DEVELOPMENT REVIEW BOARD REPORT

SUBJECT	**DC Ranch Parcel T4** **27-PP-2004**
LOCATION	E Horseshoe Canyon Drive/E Thompson Peak PY (Corner)
REQUEST	Request to approve a Preliminary Plat for 33 custom lot residences on a 39 +/- Acre parcel.

Stipulations for Case: 27-PP-2004
Case Name: DC Ranch Parcel T4

DC RANCH
SCOTTSDALE
PARCEL T4
PRELIMINARY PLAT - SITE PLAN

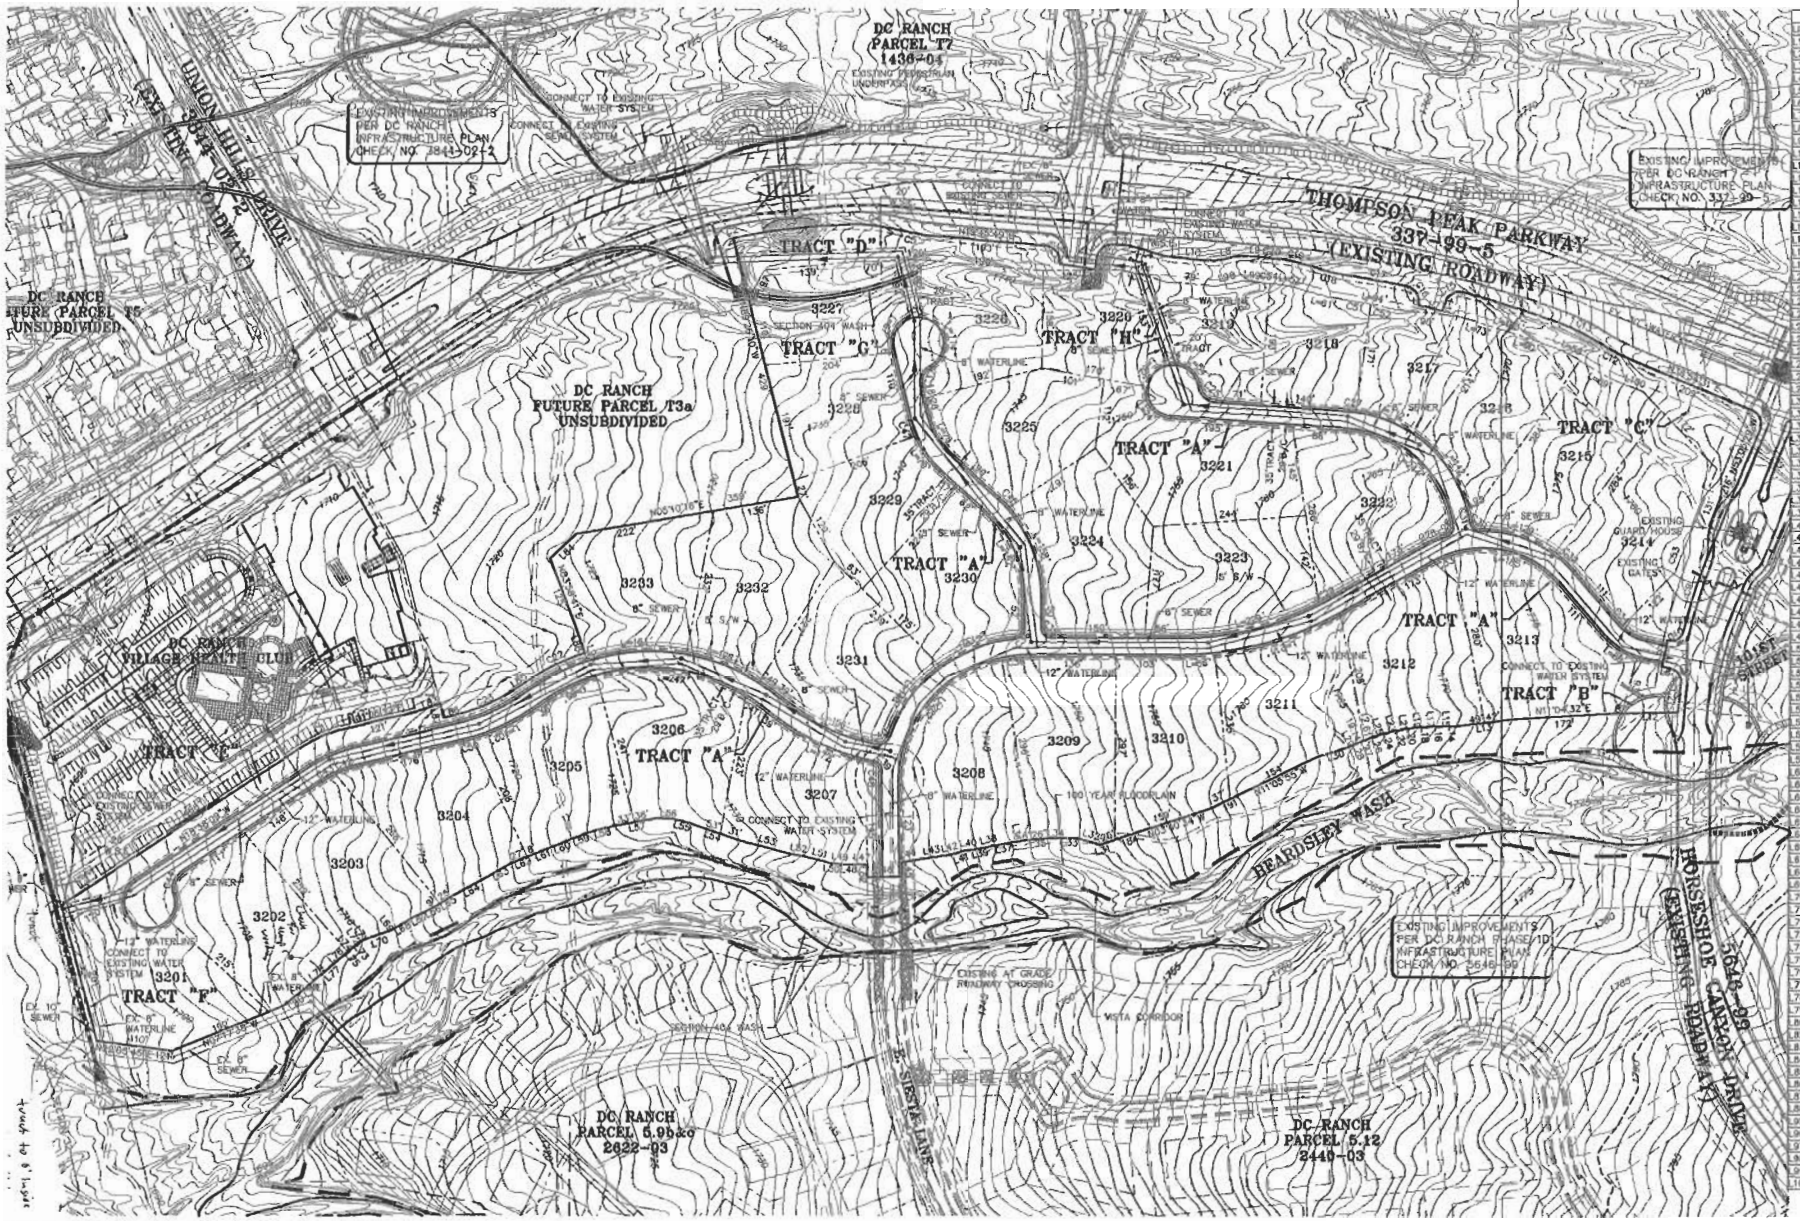
3. The preliminary plat shows a turnaround access easement for the existing E. Siesta Lane road termination. It will need to be verified that this easement is temporary in nature and will cease to exist upon recordation of the final plat for this project.

4. The preliminary plat shows a turnaround access easement for the existing water and sewer within lot 3202. It will need to be verified that this easement does not exist or is temporary in nature and will cease to exist upon recordation of the plat for this project.

12. The final plat shall be revised to provide a widened tract for the existing water and sewer lines along lot 3201 and a portion of 3202 as shown on the preliminary plat. The tract shall provide a minimum 6 feet of clearance from the inside utility or encompass the existing easement,

14. The preliminary wall and landscape plan shows a wall placed longitudinally over the proposed water and sewer along the west side of lot 3201 as shown on the preliminary plat. Walls constructed across or perpendicular to water and sewer lines, and or fire lines shall be designed (1) with gates or removable wall panels for maintenance and emergency access; or, (2) as a standard wall and the developer shall indemnify utility companies from damage to walls associated with repair of water and sewer lines.

16. Water and sewer easement shall be dedicated by separate instrument for the water and sewer tie-in on planning parcel T3A located near lot 3227 as shown on the preliminary plat.
